RE: Revised Two Rivers Slope Analysis
Technical Adequacy Review
DRMS Letter Date June 1, 2022

TECHNICAL ADEQUACY REVIEW LETTER

Date: June 1, 2022
To: Rob Zuber
CC: Jason Musick, Michael Cunningham
From: Zach Trujillo
RE: Two Rivers Application, DRMS File No. M-2022-013
Technical Adequacy Review

NON-SEISMIC STABILITY MODEL OUTPUTS

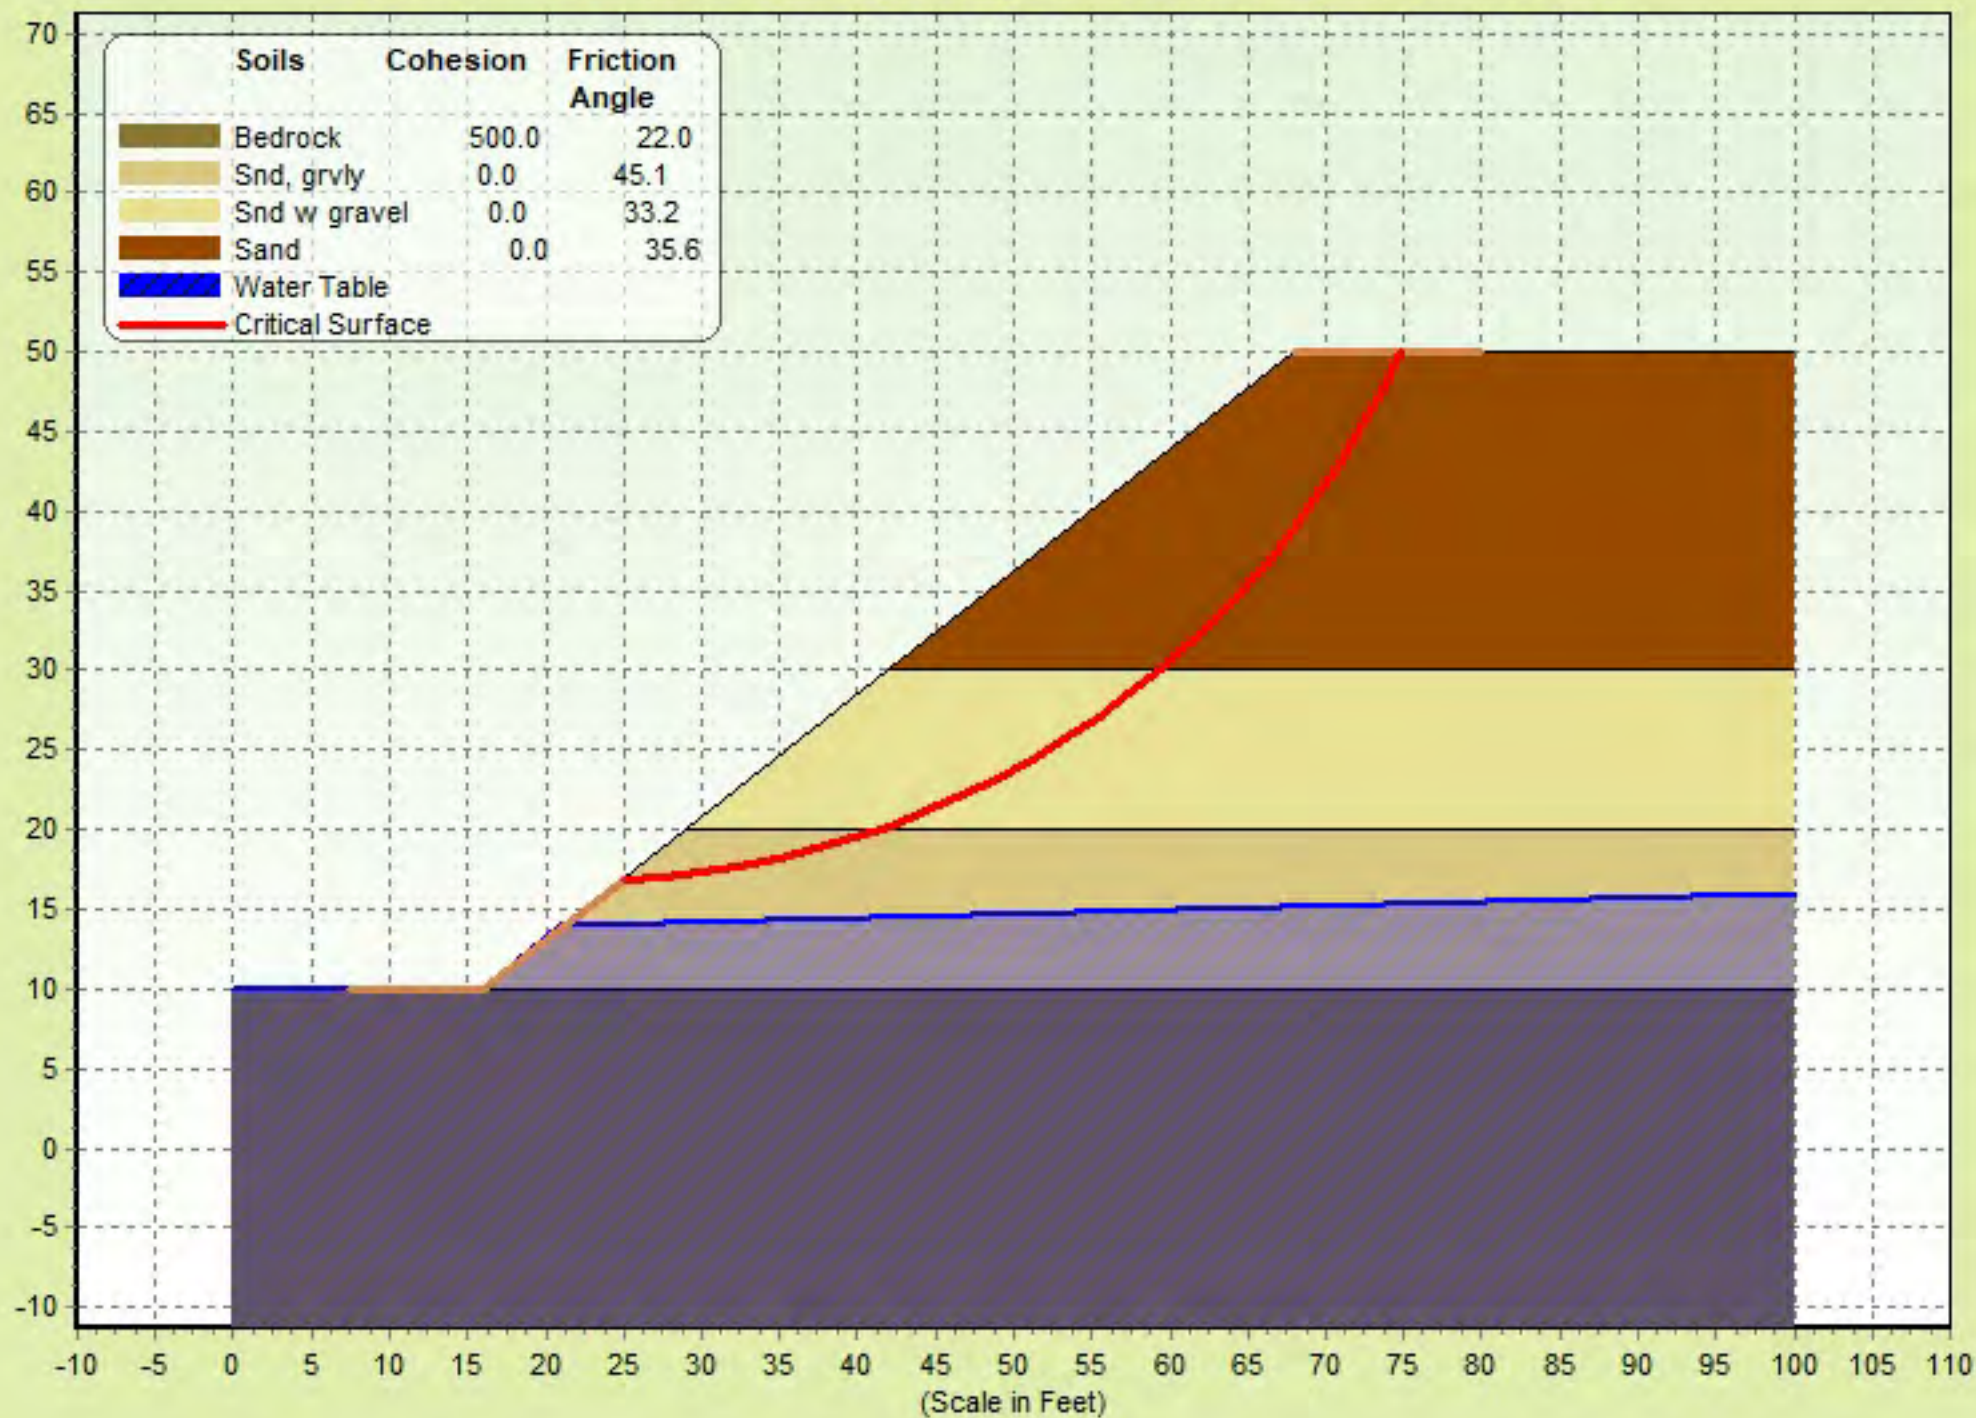
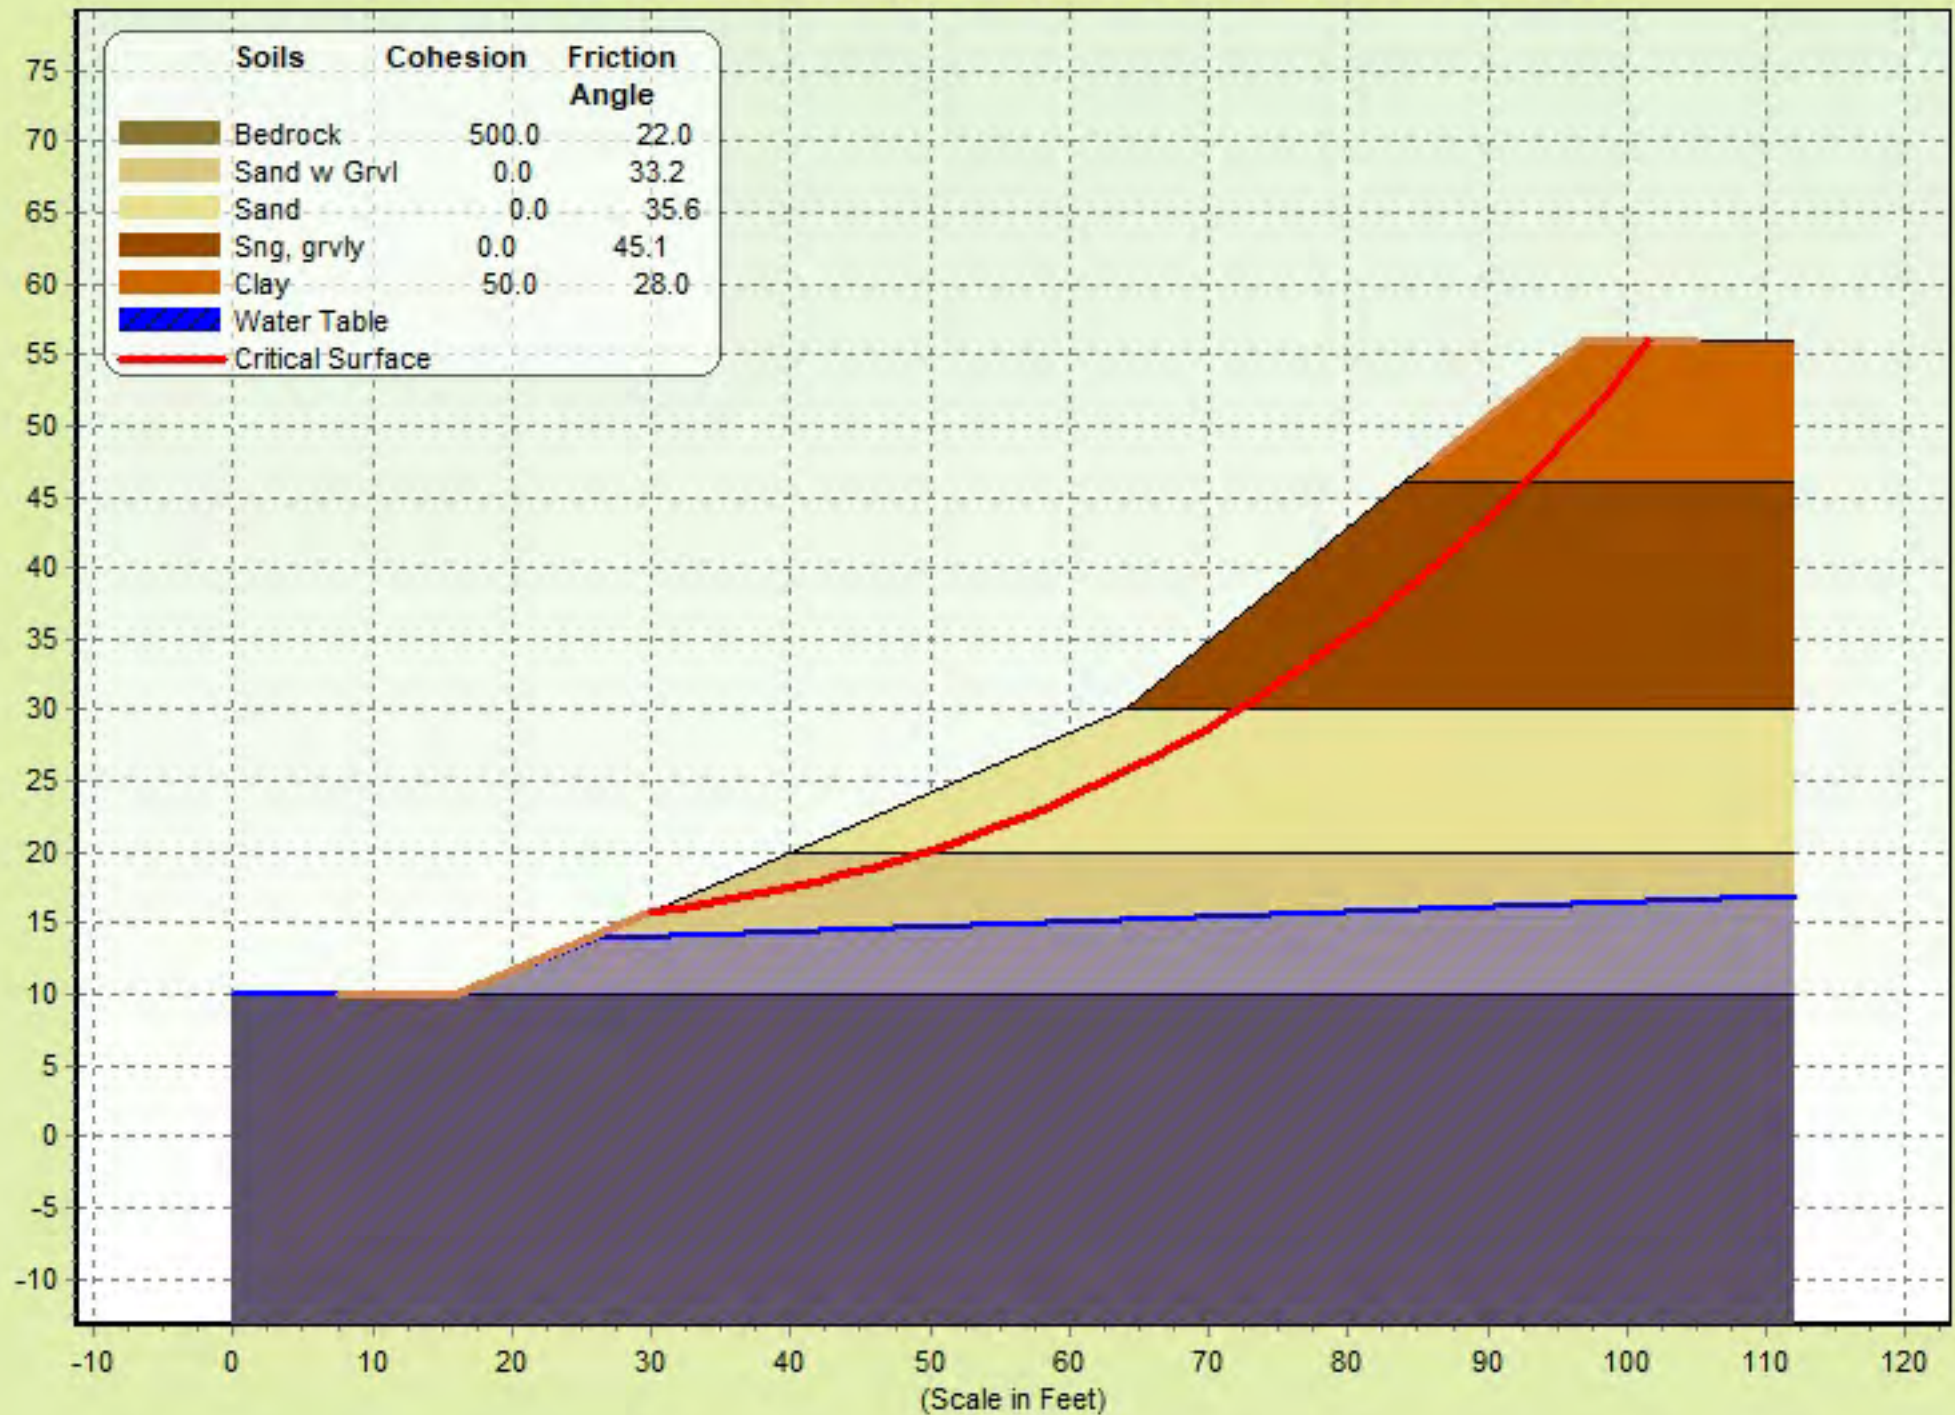
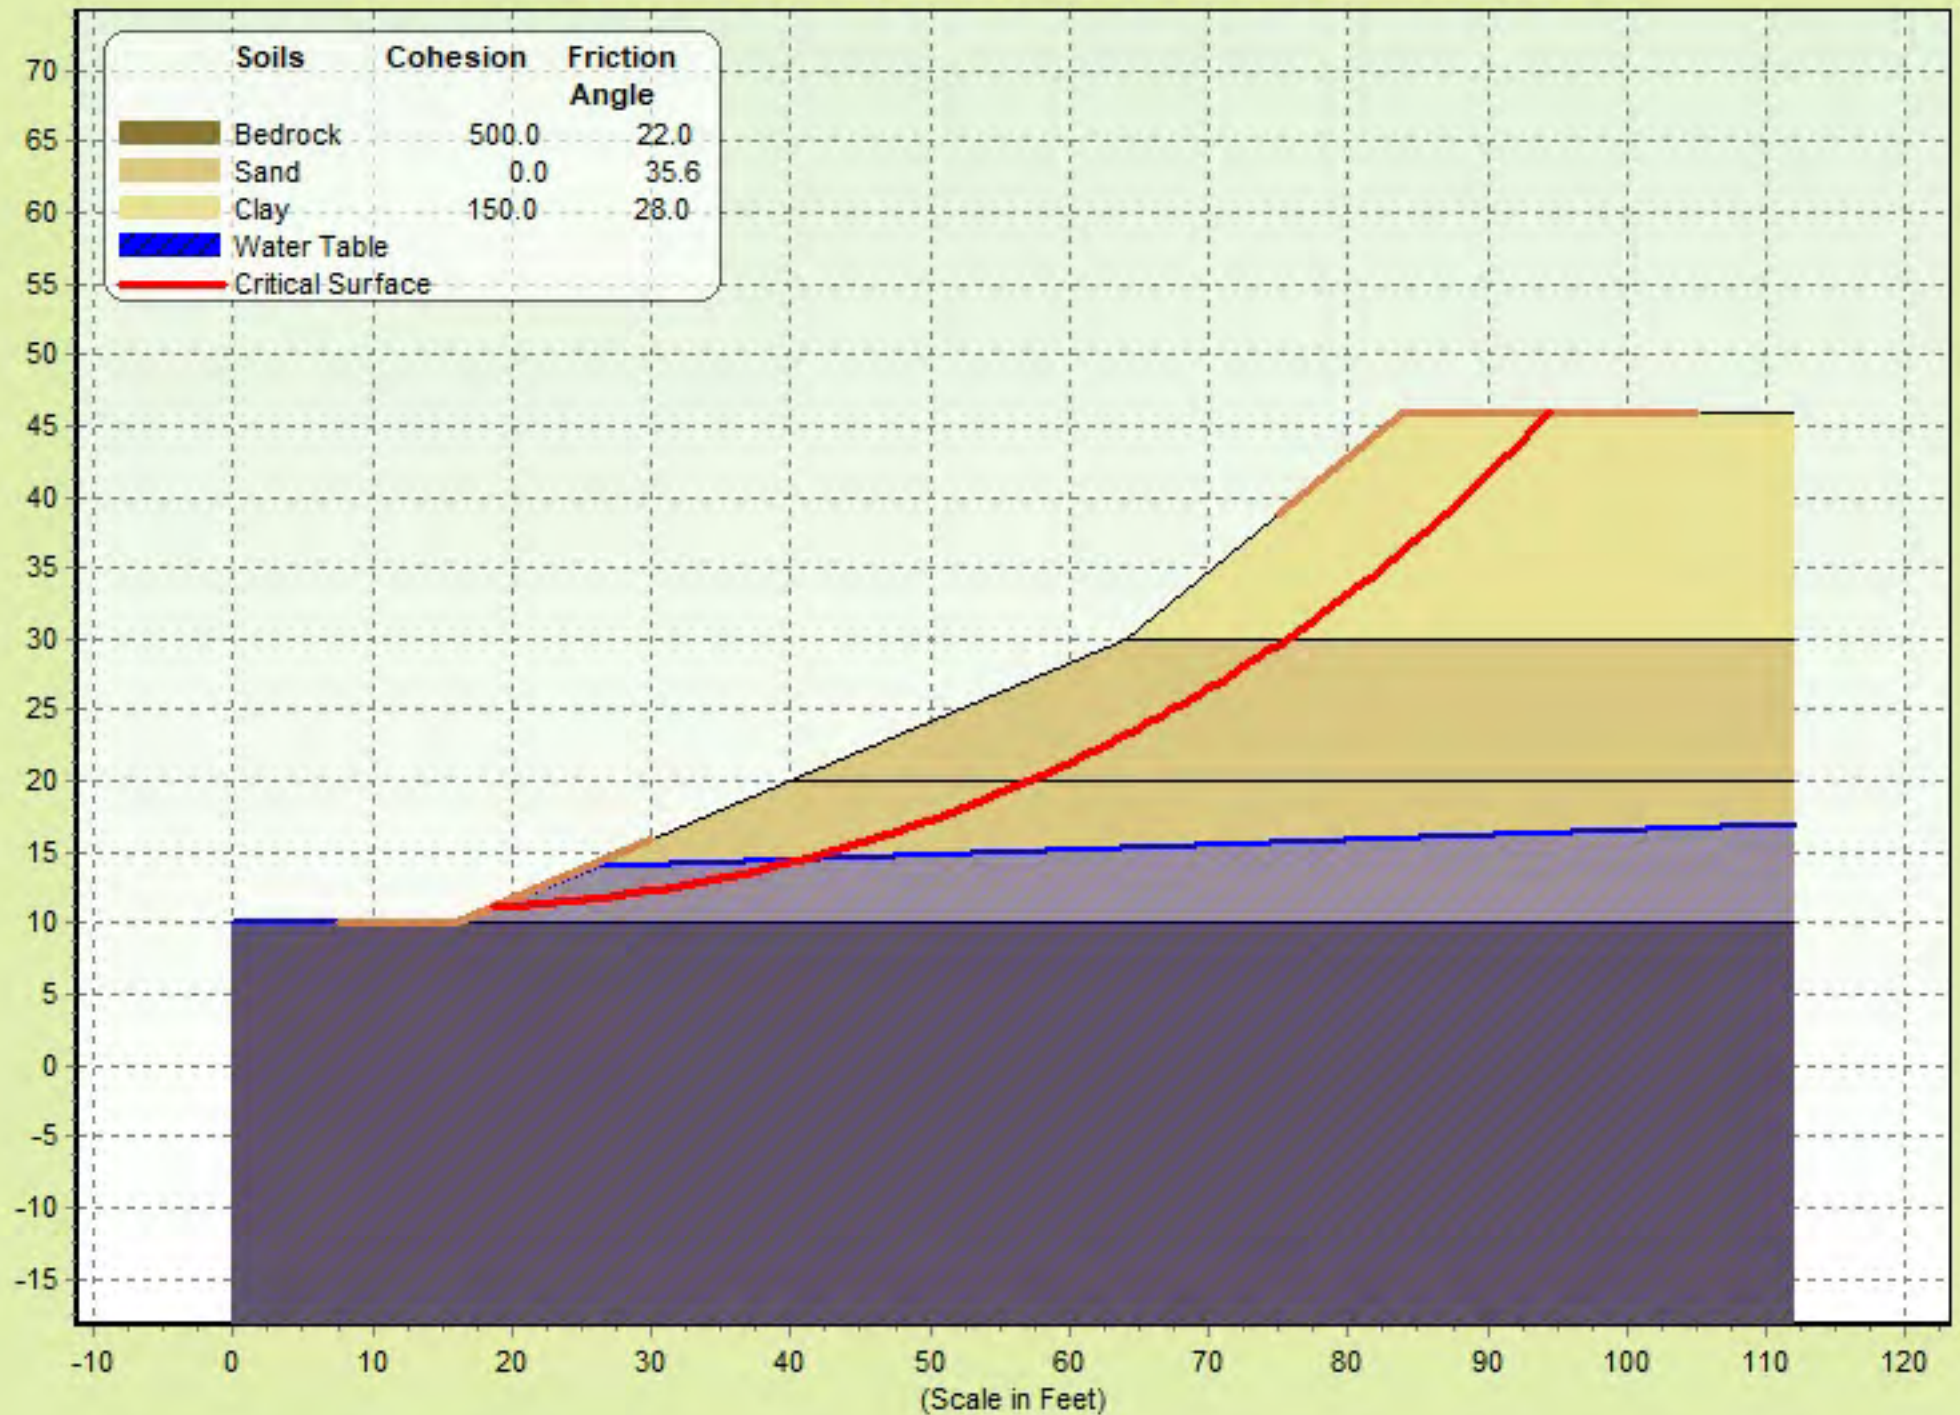
1. **Comment 1 – Please provide an updated slope stability models and associated FoS using the correct friction angle for bedrock.** We reran the four slope configurations with the suggested friction angle of 22 degrees. Predicted factors of safety for the four mine wall scenarios varied between 1.3 and 1.5. Model outputs are presented in Attachment B.

Each resulting FoS from the four analyses indicate slope stability however, there appears to be inconsistencies in the friction angle used for Bedrock as detailed in the cross-sectional slope stability result printouts provided at the end of the Report. Based on Table 1 – Soil Strength Properties, Bedrock has been assigned a friction angle of 22 degrees however of the four analyses, only Plate 4 uses this friction angle. Plate 1, 2 and 3 use a friction angle of 14 degrees. Please see Comments at the end of this memo for requested information.

1. **Please provide updated slope stability models and associated FoS using the correct friction angle for bedrock.**
2. **Please provide additional discussion in regards to conditions or scenarios which determine one of the four proposed highwall slope configuration.**
3. **Please provide slope stability analyses for the four highwall scenarios under seismic conditions including rational for the seismic coefficient used in the analyses.**
